DEVELOPMENT REVIEW BOARD REPORT

87-DR-2004#6
Hayden Peak Crossing Pad C

Request approval of a site plan and elevations for a 6,052 square foot restaurant building on Pad C of the Hayden Peak Crossing shopping center.

PAD 'C' NORTH ELEVATION
SHEET 00-00PAD 'C' EAST ELEVATION
SHEET 00-00PAD 'C' WEST ELEVATION
SHEET 00-00PAD 'C' SOUTH ELEVATION
SHEET 00-00

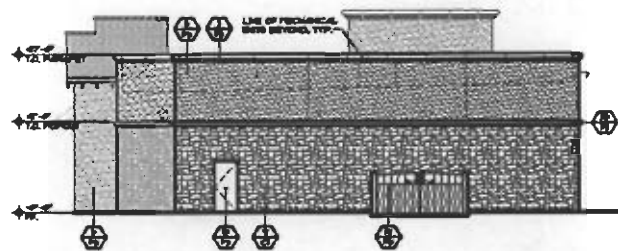
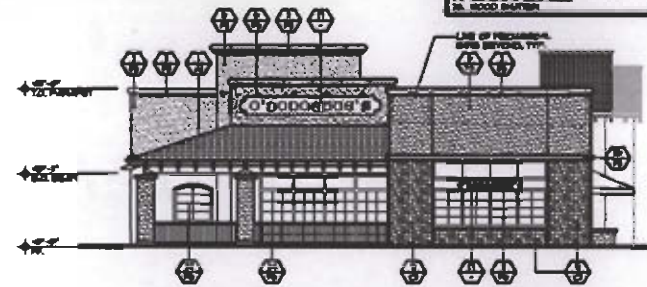
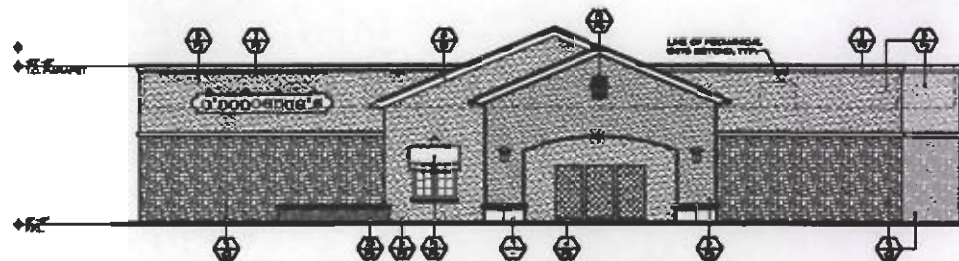
However, some minor deviations remain. With stipulations staff does not object to these. They include:

1. Small sized goose neck lamps above signage at the upper levels of the building. The applicant has agreed to a stipulation that these lamps

shall be deleted.

2. A single shutter attached on one side of the north elevation upper level window which compares to the Shops B which has windows with shutters on both sides.
3. Stylized restaurant front doors as distinguished from the standard store front doors on the other buildings.
4. The drawings show faux windows painted dark brown on the west elevation adjacent to the patio. The upper level window on the north side of the building also appears to be a faux window. The applicant has verbally indicated that these windows are to be real. Initially these were proposed as internally backlit but that notation is not on the revised plans. The applicant has agreed to a stipulation to require windows with internal back lighting.

2. The proposed faux windows shall be designed as windows with internal back lighting.
3. All window glazing shall be clear non-reflective.
4. The face of the service entrance section(s) shall be flush with the building façade and painted to match the building.

16. The goose neck style lamps are not approved and shall be deleted from all plans and documents.
17. All exterior luminaires shall meet all IESNA requirements for full cutoff, and shall be aimed downward and away from property line, except sign and landscape lighting.
18. The individual luminaire lamp shall not exceed 250 watts.
19. The maximum height from finished grade to the bottom of the any exterior luminaire shall not exceed 16 feet.
20. All exterior light poles, pole fixtures, and yokes shall be a flat black or dark bronze.
21. No lighting shall be permitted in dedicated NAOS easements, and Vista Corridor easements.
22. Incorporate into the project's design, the following:
